TRE-APP-APP21-38800703 - PLAT-20-11800227 - Rancho Carlota Unit 2

SCOPE OF WORK: PLATTING AND TREE REMOVAL FOR RESIDENTIAL DEVELOPMENT

APPROVED TREE PLAN FOR UNITS 2, 3, 5 & 8 ONLY

// STATUS: APPROVED (2010 TREE SURVEY METHOD)

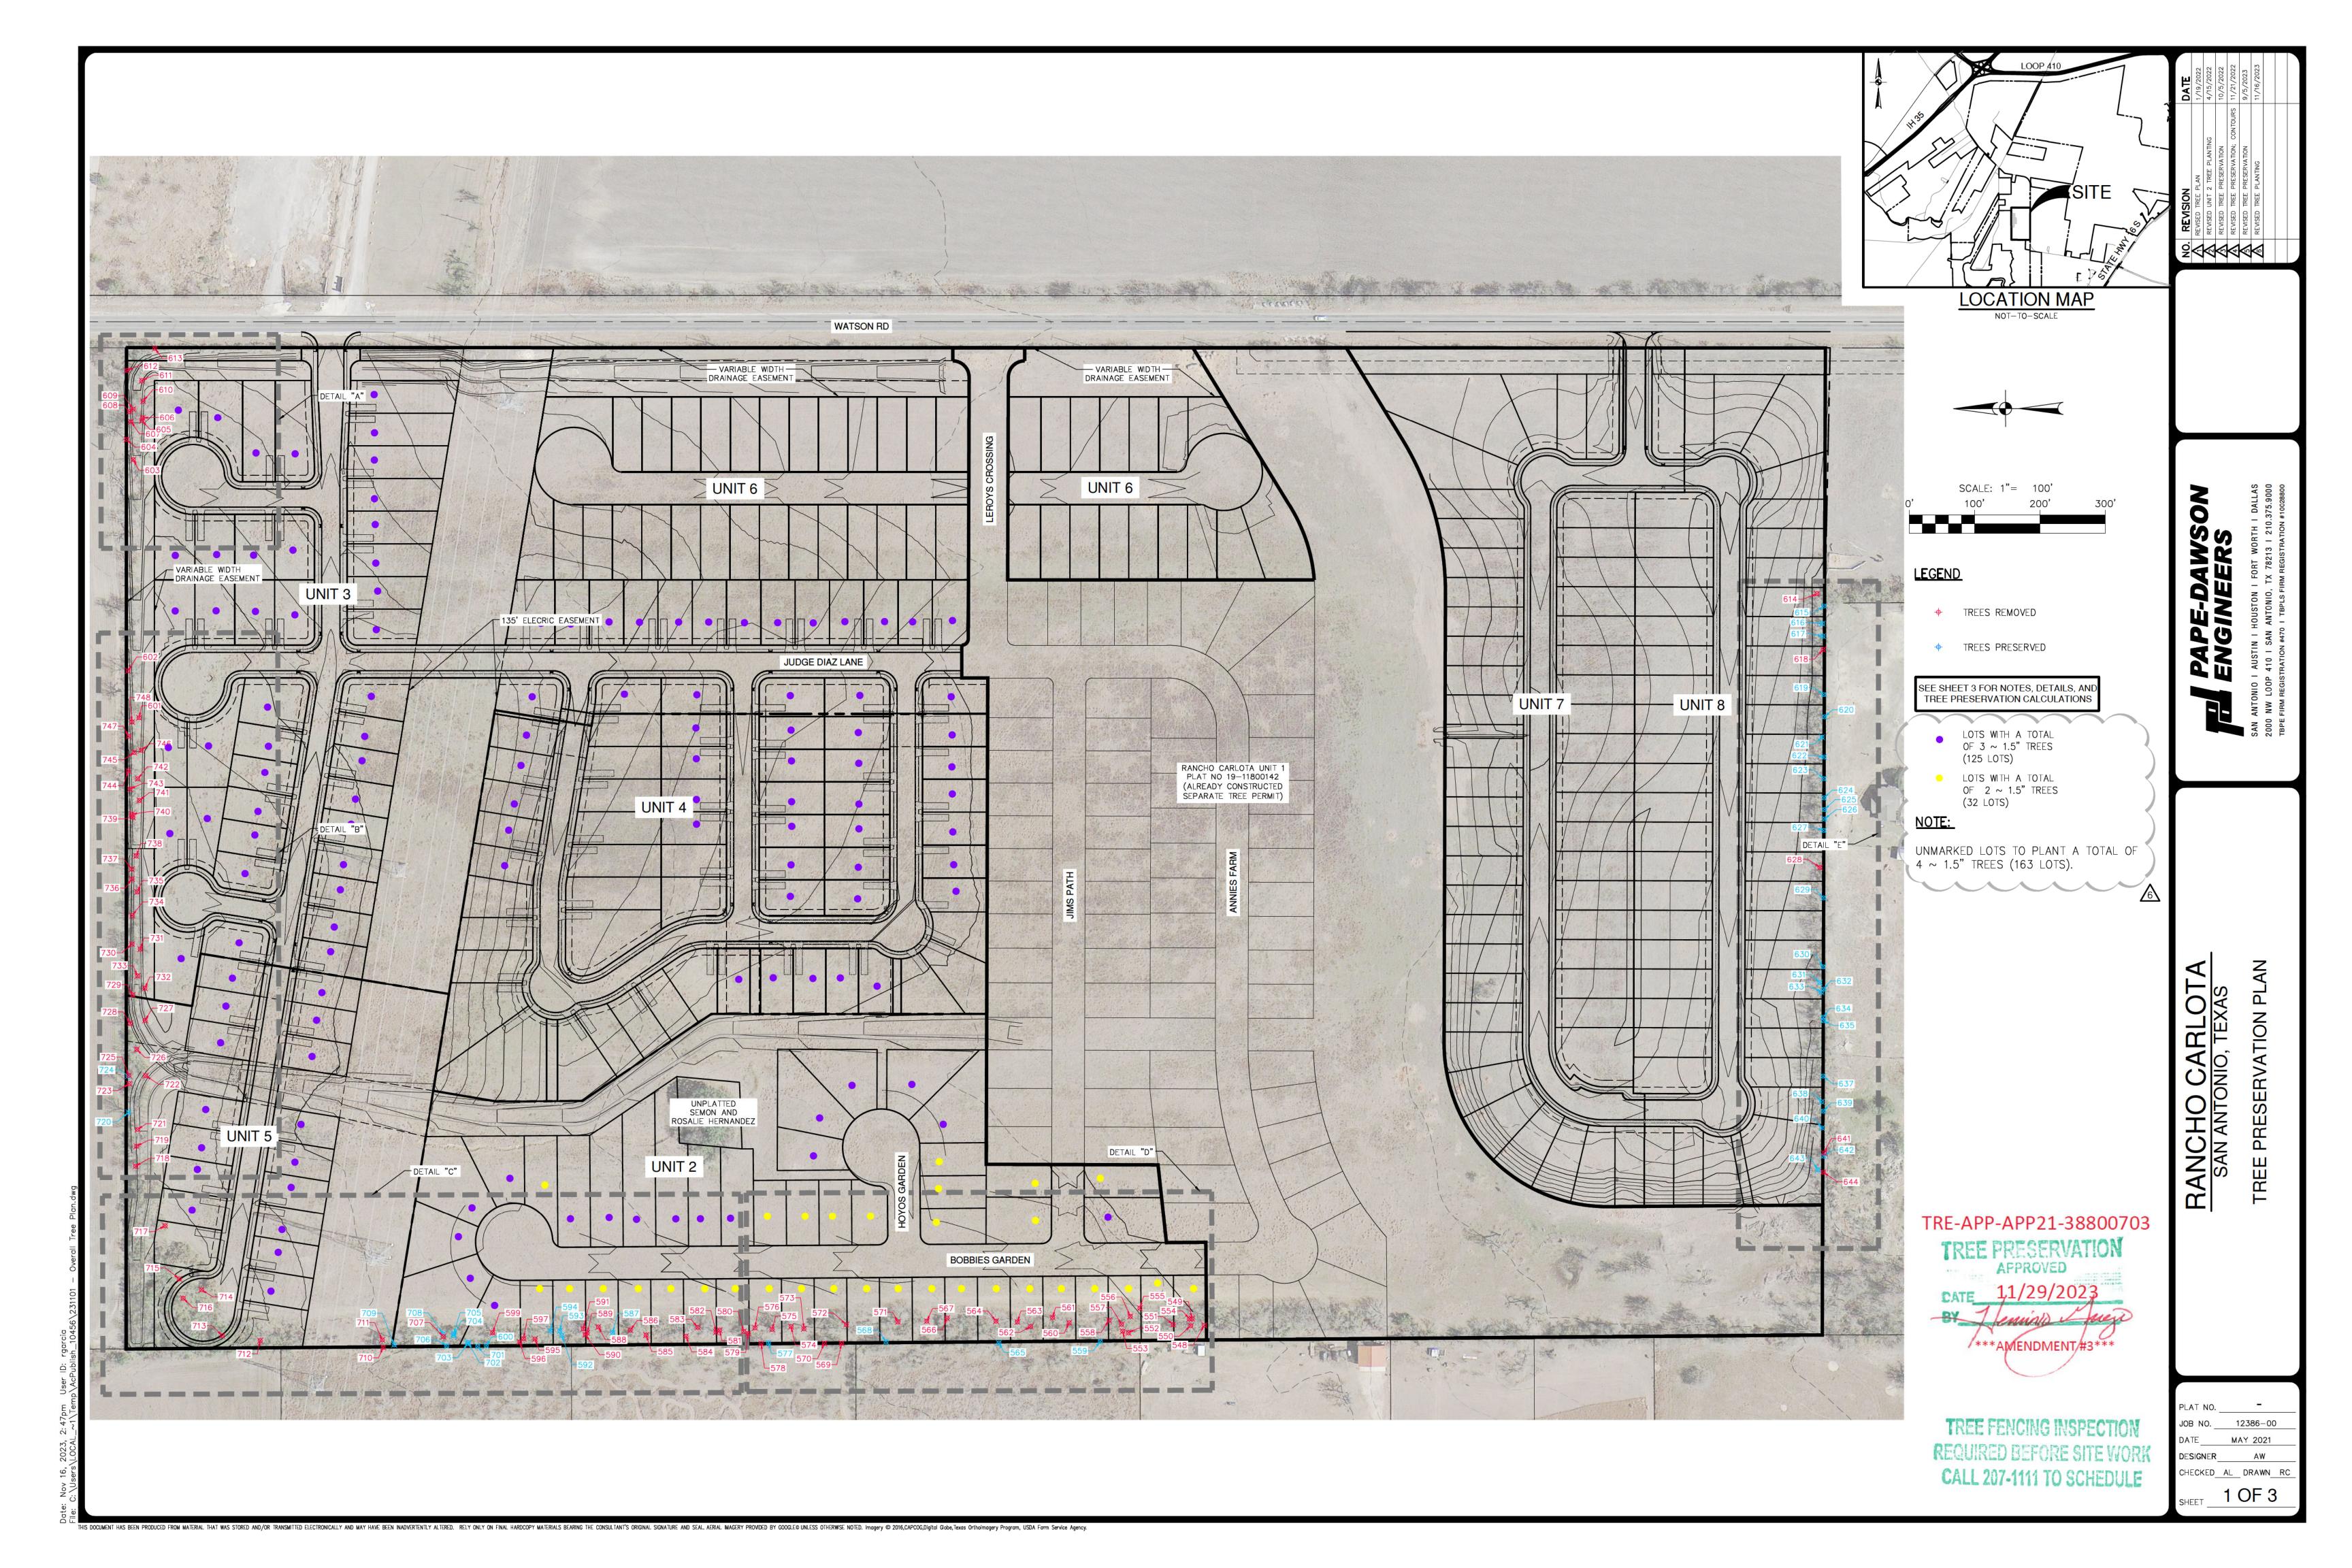
- -(4)-1.5" CALIPER NATIVE MEDIUM TO LARGE SHADE TREES REQUIRED PER LOT AT BUILDING STAGE WITHIN UNITS 6, 7, & 8 FOR MITIGATION AND TREE CANOPY COVER REQUIREMENTS. 2 OUT OF THE 4 TREES SHALL BE PLANTED ON THE SOUTH OR WEST SIDE OF BUILDING FOR ENERGY CONSERVATION CREDIT.

- -(3)-1.5" CALIPER NATIVE MEDIUM TO LARGE SHADE TREES REQUIRED PER LOT AT BUILDING STAGE WITHIN UNITS 2, 3, 4, & 5 FOR MITIGATION AND TREE CANOPY COVER REQUIREMENTS. 2 OUT OF THE 3 TREES SHALL BE PLANTED ON THE SOUTH OR WEST SIDE OF BUILDING FOR ENERGY CONSERVATION CREDIT.

- -NO STREETSCAPE OR TREE CANOPY BOND REQUIRED.
- -THIS SUBDIVISION IS SUBJECT TO A MASTER TREE PLAN (TRE-APP-APP21-38800703) WHICH REQUIRES COMPLIANCE BY THE OWNERS OF ALL PROPERTY WITHIN THE PLAT BOUNDARY, AND THEIR EMPLOYEES AND CONTRACTORS, AND SHALL BE BINDING ON ALL SUCCESSORS IN TITLE EXCEPT FOR OWNERS OF SINGLE-FAMILY RESIDENTIAL LOTS SUBDIVIDED HEREUNDER FOR WHICH CONSTRUCTION OF A RESIDENTIAL STRUCTURE HAS BEEN COMPLETED. THE MASTER TREE PLAN IS ON FILE AT THE CITY OF SAN ANTONIO ARBORISTS OFFICE. NO TREES OR UNDERSTORY SHALL BE REMOVED WITHOUT PRIOR APPROVAL OF THE CITY ARBORIST OFFICE PER 35-477(H).

- -PRIOR TO COMMENCEMENT OF ANY ACTIVITIES REQUIRING A TREE PERMIT, THE APPLICANT SHALL SCHEDULE A PRE-CONSTRUCTION MEETING WITH THE CITY ARBORIST TO REVIEW PROCEDURES FOR PROTECTION AND MANAGEMENT OF ALL SIGNIFICANT, HERITAGE OR MITIGATION TREES (CAN BE SCHEDULED WITH TREE FENCING INSPECTION).

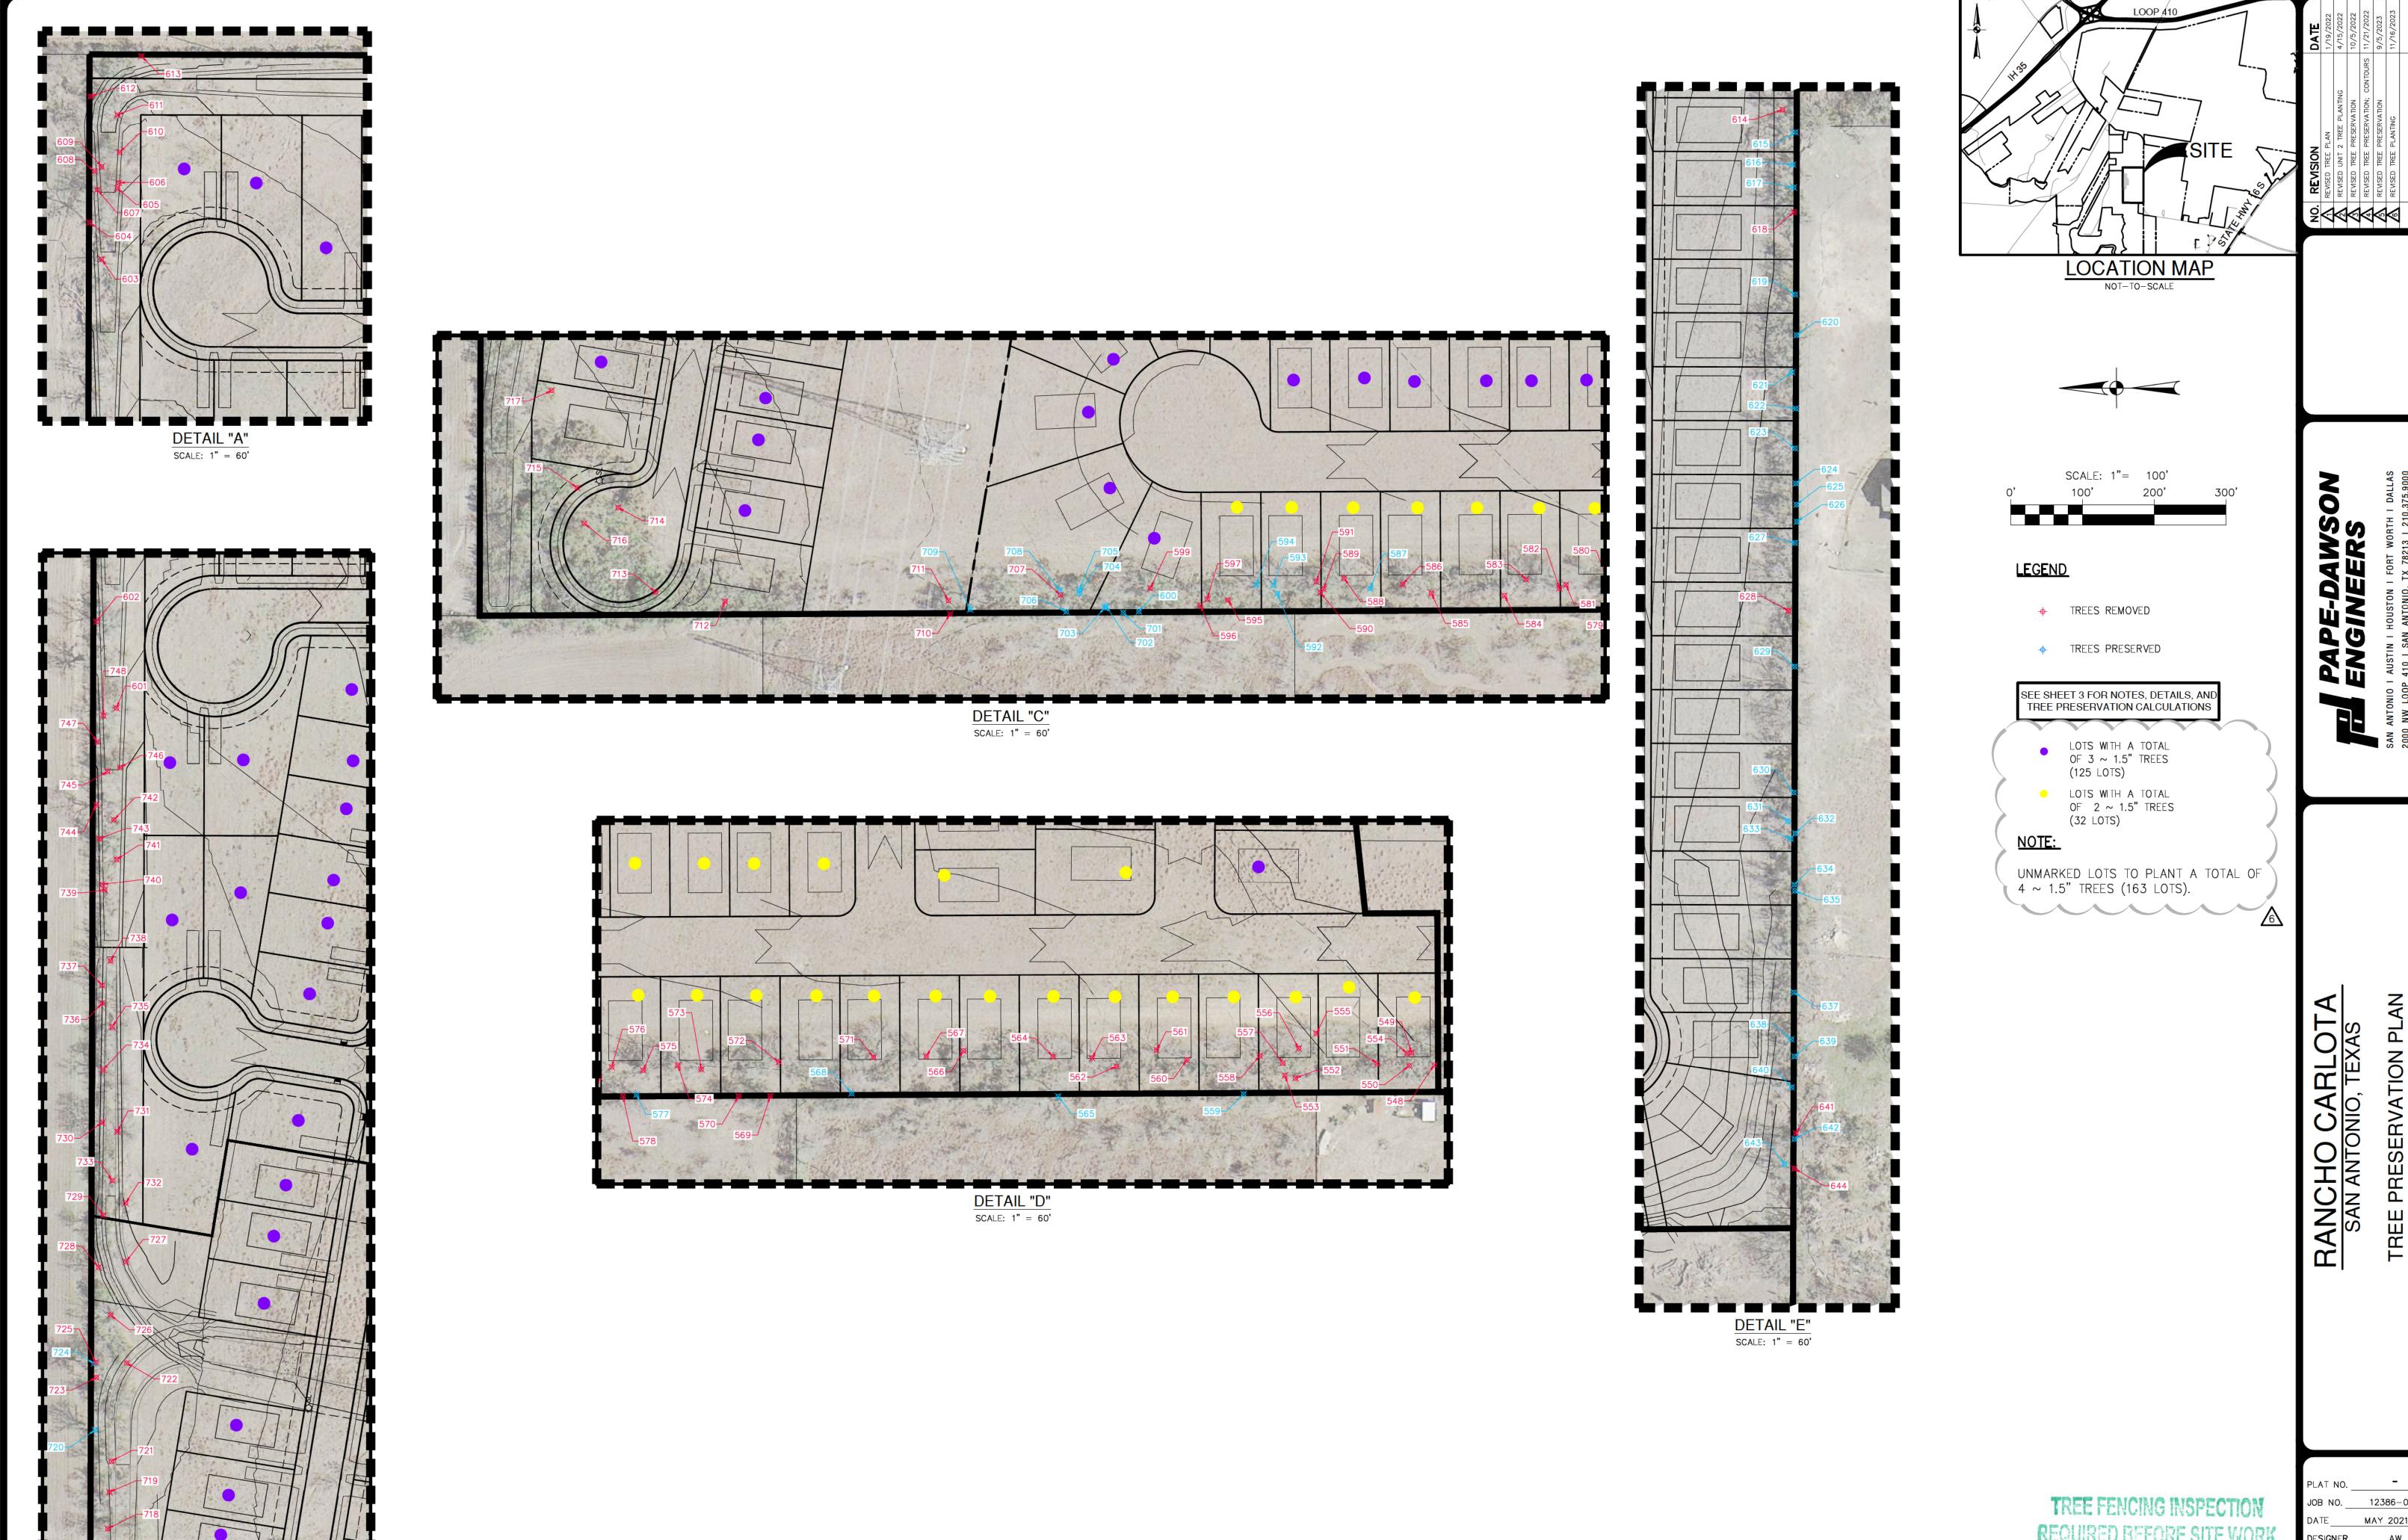
// NOTE: APPLICATION IS FOR PLATTING AND TREE REMOVAL PURPOSES. TREE REVIEW APPROVAL IS FOR TREE REMOVAL WITHIN UNIT 2 ONLY. ANY SITE WORK OR TREE REMOVAL OUTSIDE OF UNIT 2 SHALL REQUIRE A SEPARATE TREE APPLICATION BE SUBMITTED AND APPROVED PRIOR TO START OF WORK.
